REPORT TO COUNCIL

Application: DP16-0152 & DP16-0192 **Owner:** Acorn Resorts GP Ltd., Inc.
No. BC0888222

Address: 3450 McKinley Beach Dr **Applicant:** GTA Architecture

Subject: Development Permit Applications

Figure 2.0: Site Plan

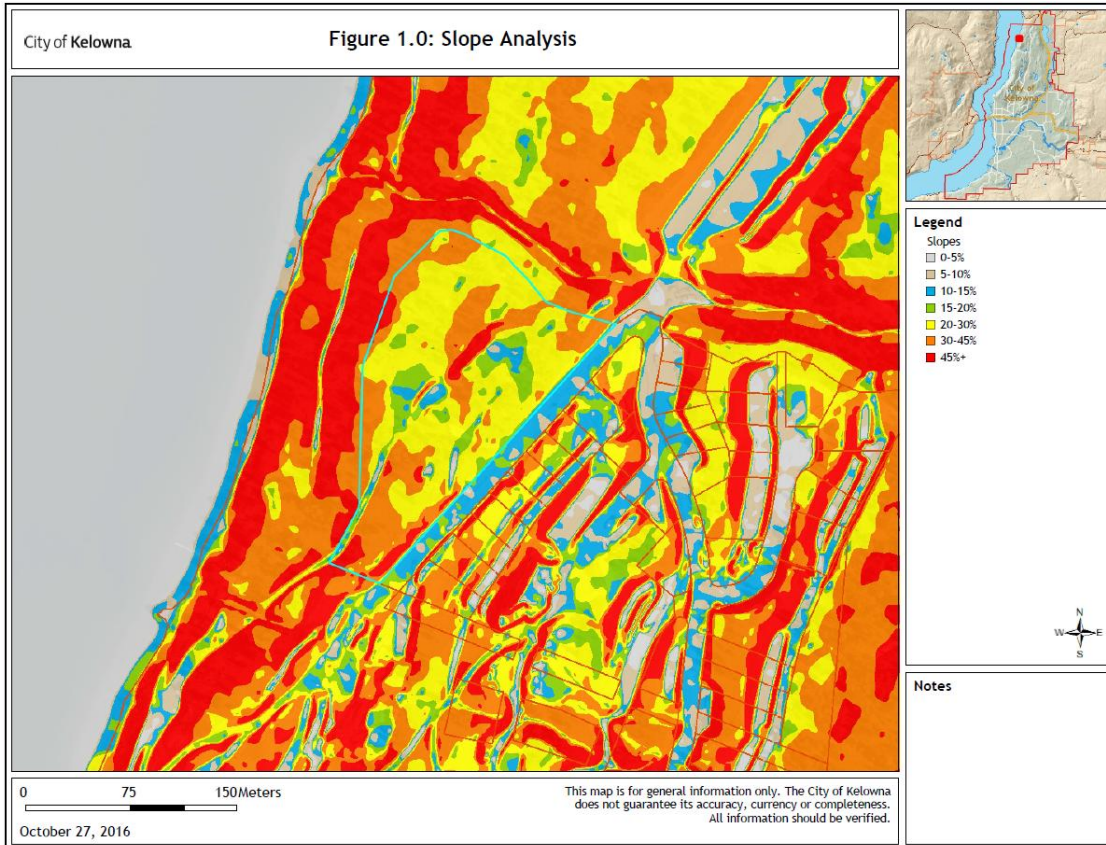
The buildings are oriented with the natural topography (i.e. the greatest horizontal dimension is parallel with, not perpendicular to, the natural contour of the land). Although, the individual buildings do not ‘step back’ with the slope (as per the hillside guidelines), the location of the semi-detached dwellings downslope of the 5 ½ storey multi-family buildings will provide a transitional appearance for the overall site. The choice to limit the multi-family building to a single loaded corridor helps reduce the bulk and massing of the buildings. Further, the applicant has provided a landscape plan and a site restoration plan associated with a three-year maintenance plan that should help to mitigate the disturbed areas. Community Planning is supportive of the Development Permit in order to achieve the approved density in the neighbourhood.

The subject property is currently vacant. The proposal contains a strata road running north-south with the semi-detached units located on the west side of the road or on the downslope portion. The 64-unit multi-family buildings are located upslope and to the east of the strata road. The project proposes a single loaded corridor with all the suites facing the lake. See applicant’s rationale letter for more detail of the proposal.
